STROMBERG-CARLSON NO. 1100 AC-DC RADIO RECEIVERS

1100 RECEIVER—CHANGE IN RECTIFIER CIRCUIT

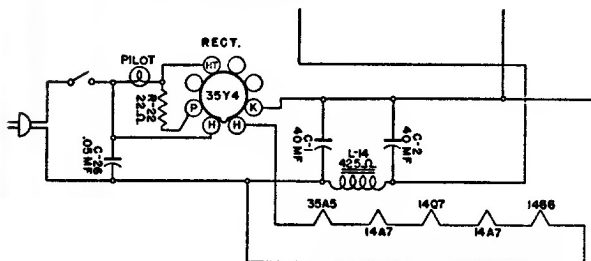
Field Coil of Speaker has been removed from negative side of Rectifier Circuit to positive side.

CIRCUIT BEFORE CHANGE
Using Capacitor 34506 C-1, C-2

CIRCUIT AFTER CHANGE
Using Capacitor 111001 C-1, C-2
